CCN: 033132

**CONTRACT NO. DE-AC27-01RV14136 – TRANSMITTAL FOR APPROVAL:
AUTHORIZATION BASIS CHANGE NOTICE 24590-WTP-ABCN-ESH-01-001,
REVISION 1, "REVISION TO ISM PROCESS & DEFENSE IN DEPTH (SRD)
APPENDICES A & B"**

Figure A-1 SRD Compliance Process

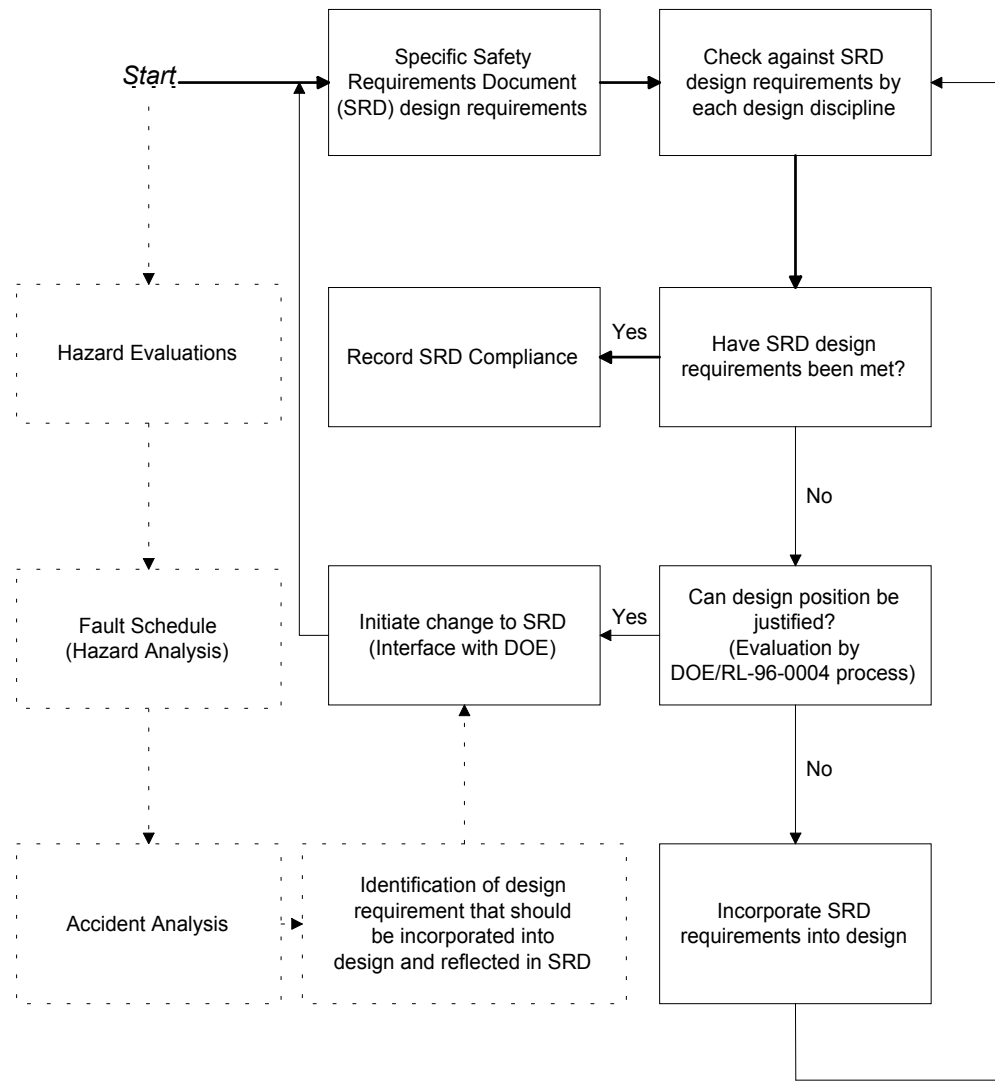
7. Add new section 11.0, Maintenance of the SRD. Change Sections 11.0 and 12.0 to 12.0 and 13.0 respectively.
8. Add new figure A-1, SRD Compliance Process.

- 7) to add the only part of the SRD standard selection process that is not included in Appendix A and to facilitate cancellation of SRD Volume I.
- 8) Figure A-1, SRD Compliance Process is added for clarity and to facilitate cancellation of SRD Volume I.

11.0	Add new figure A-1, SRD Compliance Process	As SRD Volume I is to be deleted, this figure needs to be relocated from Volume I, Section 3.6. The figure provides clarification of the SRD Compliance Process.

Consistency of the SRD with current design information, hazards assessment, hazards control, and selected standards during the SRD development is ensured by participating with the personnel responsible for design and hazards analysis activities in the SRD development process as well as through reviews of the SRD, HAR, and design information. Additionally, for design-related criteria, a review of the Safety Criteria against facility design will be conducted to ensure the Safety Criteria are met by the design. Figure A-1 depicts this process.
